ERRATA

Recirculated Portion of the Draft Revised Environmental Impact Report for the September Ranch Subdivision Project (State Clearinghouse No. 1995083033, PC 95062), County of Monterey (February 15, 2006).

SEPTEMBER RANCH SUBDIVISION PROJECT • RECIRCULATED REIR

Exhibit 4.3-4c Cross-Sections and Conceptual Modeling

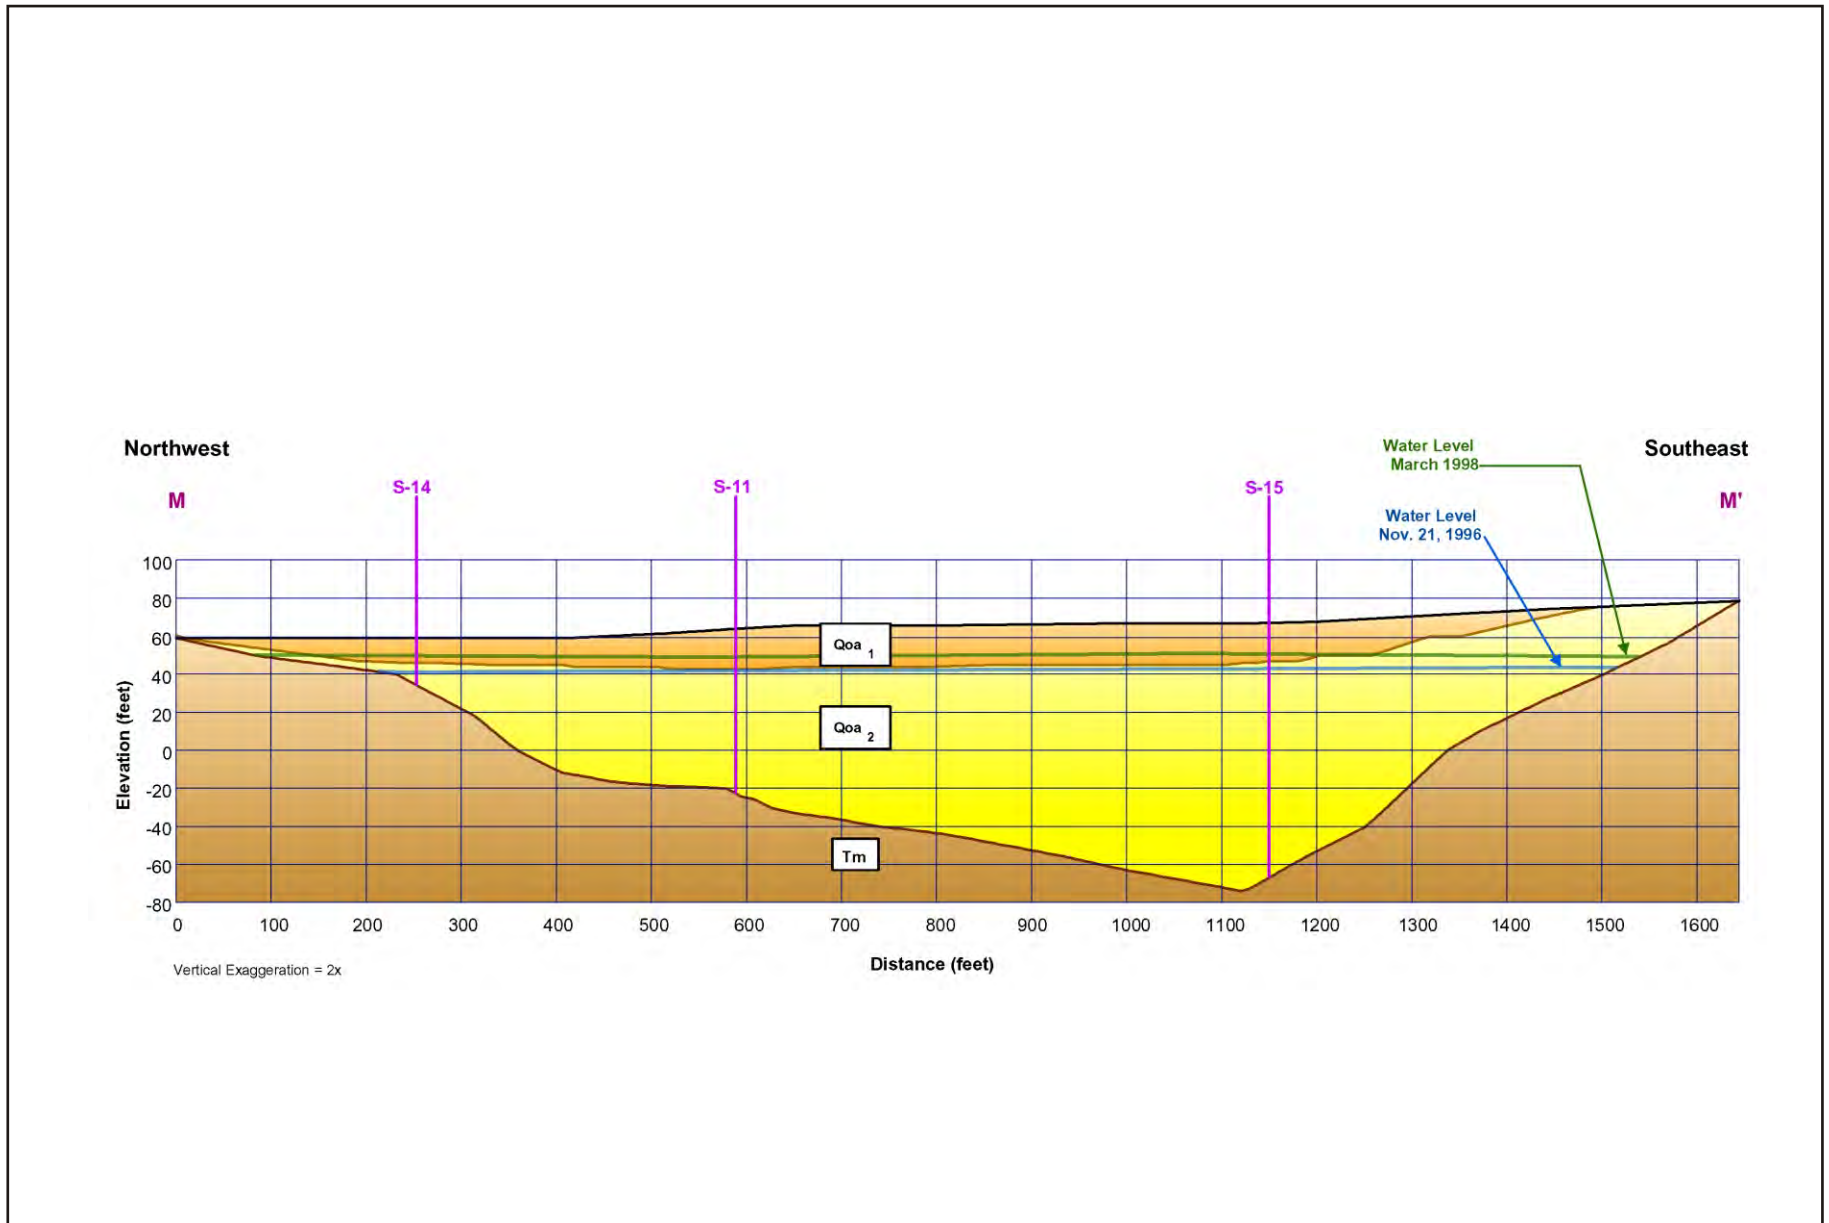
Section 4.3.3, Exhibit 4.3-4b **Water Supply and Availability**

Replace the second Exhibit 4.3-4b (included twice) with the attached Exhibit 4.3-4c.

Note: Correction of compilation error.
